UNITED STATES PATENT AND TRADEMARK OFFICE

APPLICATION NO.	FILING DATE	FIRST NAMED INVENTOR	ATTORNEY DOCKET NO.	CONFIRMATION NO.
10/784,629	02/23/2004	Joseph P. Errico	F-273	8400

Office Action Summary

DETAILED ACTION

Figure 1

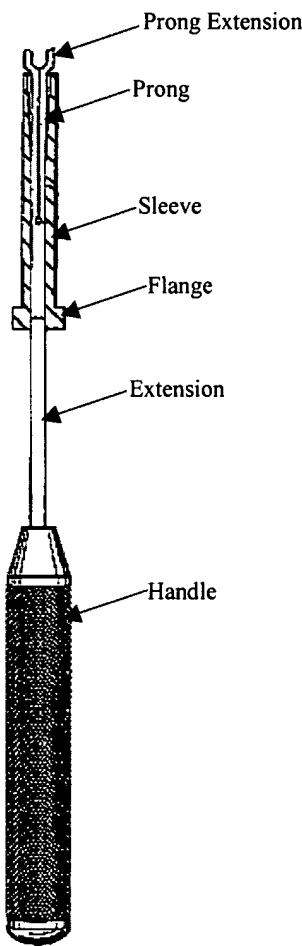
Regarding claim 1, Farris discloses a device comprising an extension having a longitudinal axis, at least two prongs, and a sleeve (see Figure 1 below). The prongs are coupled to a fulcrum located at the distal end of the extension. Each prong further includes an extension that together defines a contractible and expandable holding enclosure. The sleeve surrounds at least a portion of the distal end of the extension, is collinear with the longitudinal axis of the extension, and is rotatable about the extension. Regarding claim 3, Farris discloses a device further comprising a handle, which has a distal end connected to the proximal end of the extension. Regarding claim 4, Farris

discloses a device further comprising a flange. Regarding claim 5, Farris discloses a device wherein the holding enclosure is cylindrical. Regarding claim 15, Farris discloses a device wherein at least one prong terminates into at least one extension. Regarding claim 18, Farris discloses a device wherein at least one of the extensions is rigid (see Figure 2 below). Regarding claim 19, Farris discloses a device wherein the extensions are semicircular with inner surfaces facing each that define the holding enclosure. With regards to the statements of intended use and other functional statements, they do not impose any structural limitations on the claims distinguishable over Farris, which is capable of being used as claimed if one so desires to do so. *In re Casey*, 152 USPQ 235 (CCPA 1967) and *In re Otto*, 136 USPQ 458, 459 (CCPA 1963). Furthermore, the law of anticipation does not require that the reference “teach” what the subject patent teaches, but rather it is only necessary that the claims under attack “read on” something in the reference. *Kalman v. Kimberly Clark Corp.*, 218 USPQ 781 (CCPA 1983). Furthermore, the manner in which a device is intended to be employed does not differentiate the claimed apparatus from prior art apparatus satisfying the claimed structural limitations. *Ex parte Masham*, 2 USPQ2d 1647 (1987).

Figure 3

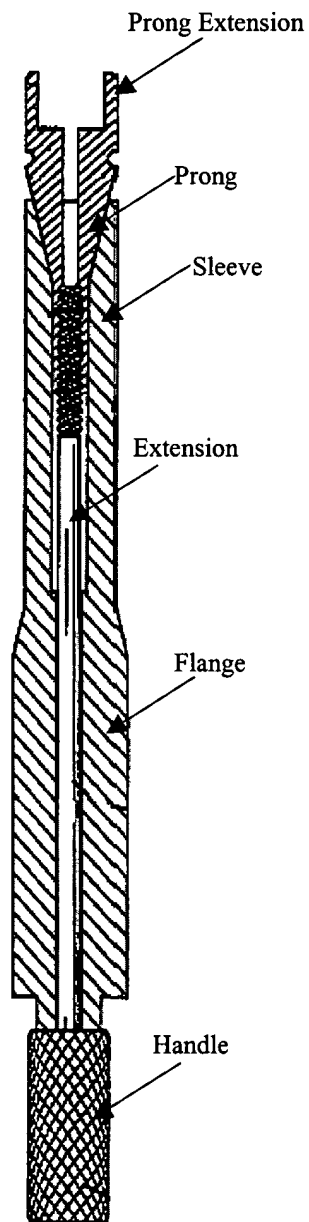
Regarding claim 1, Steffe discloses a device comprising an extension having a longitudinal axis, at least two prongs coupled to a fulcrum located at the distal end of the extension, and a sleeve (see Figure 3 below). Each prong further comprises an extension that together defines a contractible and expandable holding enclosure. The sleeve surrounds at least a portion of the distal end of the extension, is collinear with the longitudinal axis of the extension, and is rotatable about the extension. Regarding claim 3, Steffe discloses a device further comprising a handle, which has a distal end connected to the proximal end of the extension. Regarding claim 4, Steffe discloses a device further comprising a flange. Regarding claim 16, Steffe discloses a device wherein at least one of the extensions has a thickness less than the width of an annular groove on the device. With regards to the statements of intended use and other functional statements, they do not impose any structural limitations on the claims distinguishable over Steffe, which is capable of being used as claimed if one so desires to do so. *In re Casey*, 152 USPQ 235 (CCPA 1967) and *In re Otto*, 136 USPQ 458, 459 (CCPA 1963). Furthermore, the law of anticipation does not require that the reference "teach" what the subject patent teaches, but rather it is only necessary that the claims under attack "read on" something in the reference. *Kalman v. Kimberly Clark Corp.*, 218 USPQ 781 (CCPA 1983). Furthermore, the manner in which a device is intended to be employed does not differentiate the claimed apparatus from prior art apparatus satisfying the claimed structural limitations. *Ex parte Masham*, 2 USPQ2d 1647 (1987).

Figure 4

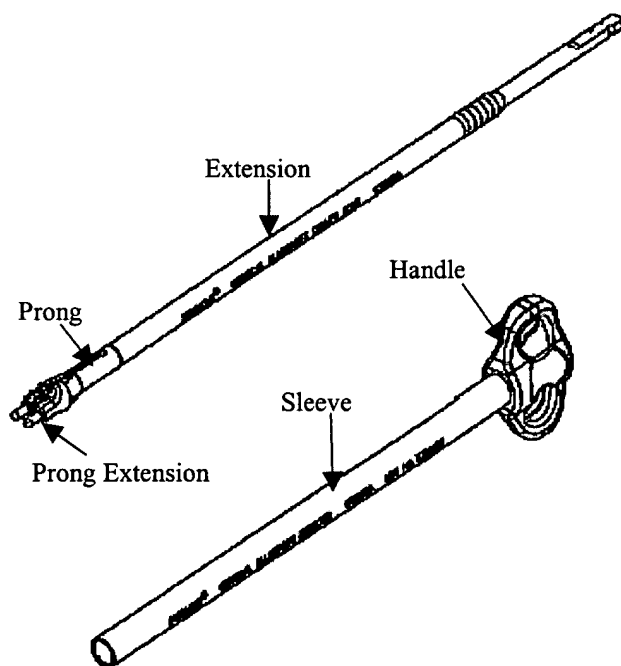
end of the extension, and a sleeve (see Figure 4 below). Each prong further comprises an extension that together defines a contractible and expandable holding enclosure.

The sleeve surrounds at least a portion of the distal end of the extension, is collinear with the longitudinal axis of the extension, and is rotatable about the extension.

Regarding claim 3, Hildebrand discloses a device further comprising a handle, which has a distal end connected to the proximal end of the extension. Regarding claim 9, Hildebrand discloses a device wherein a thread is used to limit the amount of rotation of the sleeve. Regarding claim 15, Hildebrand discloses a device wherein at least one prong terminates into at least one extension.
